## City of Lone Tree Planning Commission Agenda Tuesday, July 26, 2016

Approval of a Site Improvement Plan (SIP) for an 80,200 square-foot, two-story building, with 605 storage units, on 2.8 acres.

<p><b>Project Name and File Number:</b> Park Meadows Filing 2, 21<sup>st</sup> Amendment, Lot 14E5A-3, #SP16-33</p> <p><b>Project Type:</b> Site Improvement Plan</p> <p><b>Comments Due By:</b> July 6, 2016</p> <p>If you are unable to respond by the due date, please contact the project planner</p>
---

**LONE TREE SELF STORAGE**  
**LONE TREE, COLORADO**  
**SITE IMPROVEMENT PLAN**  
**GRADING PLAN**

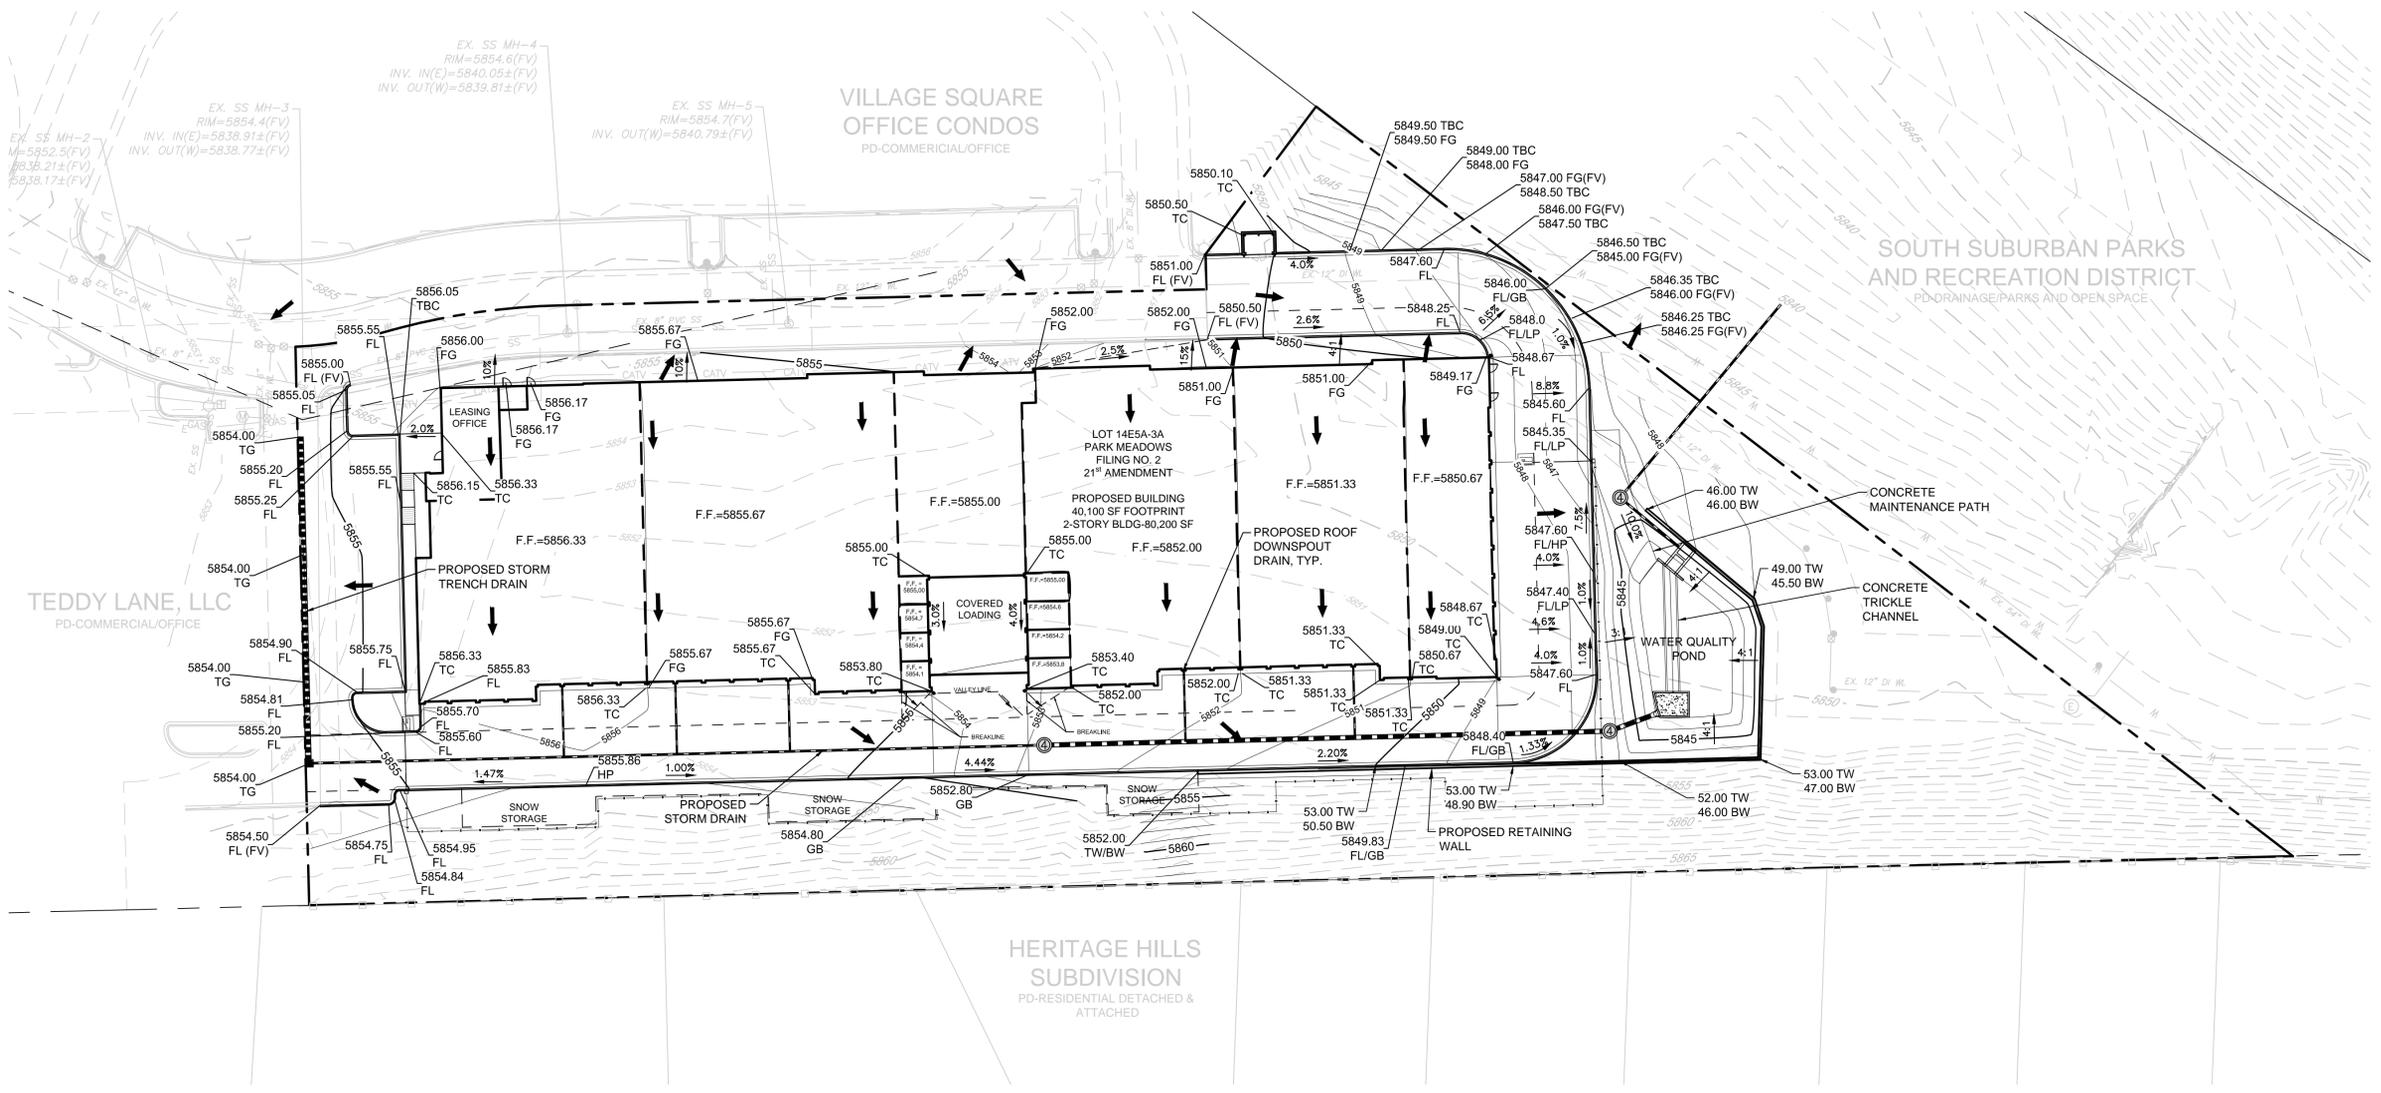
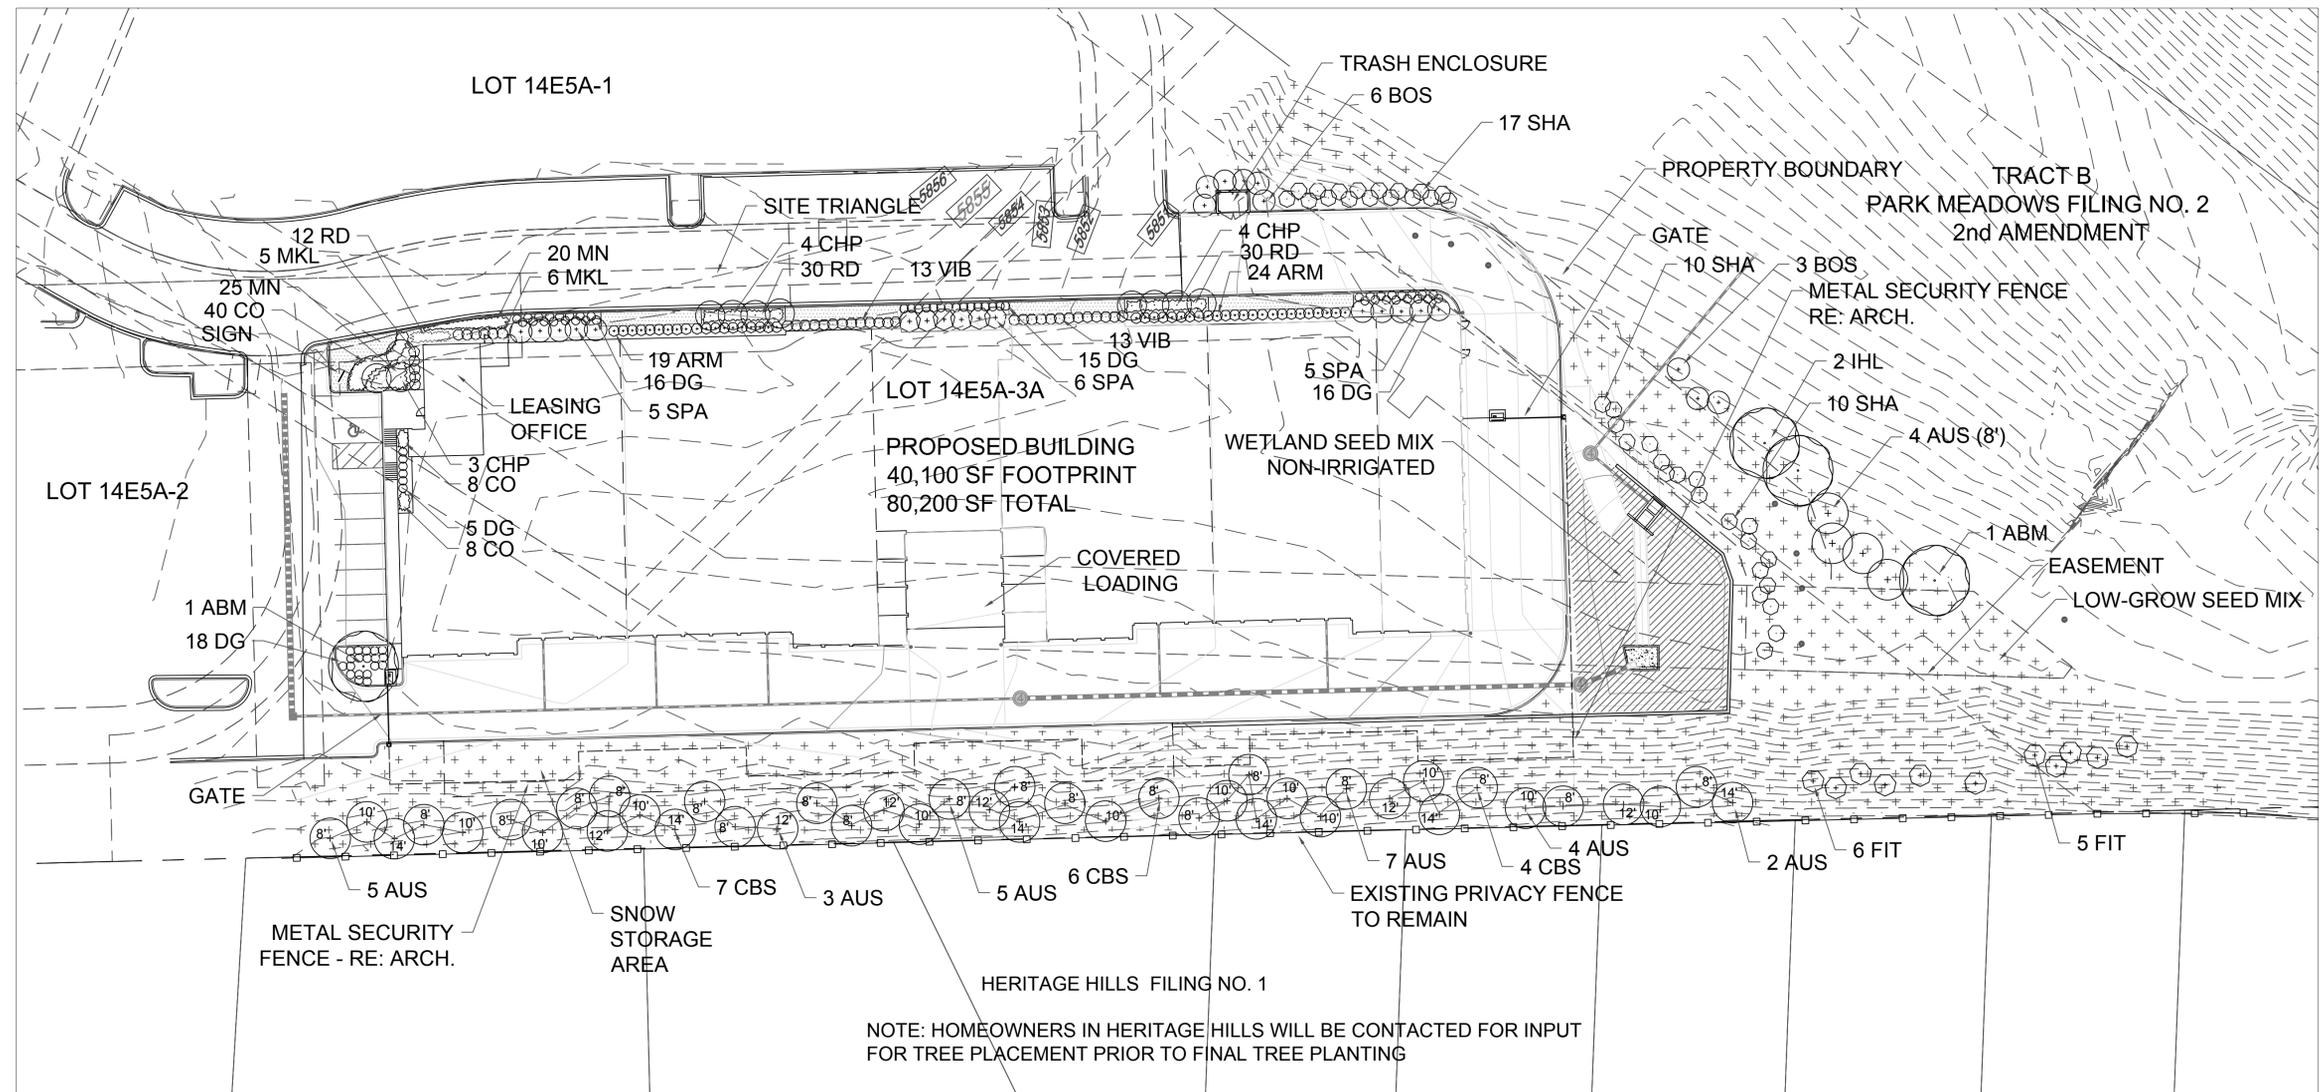
Sheet 3 – Grading Plan: The cross slope of 8.8% on the eastern drive around the building is quite steep, and may create some difficulty in this area, especially during icy winter conditions. We understand there are site constraints that have resulted in this proposed grade, but would recommend a maximum cross grade of approximately 5% for the parking/drive lane.
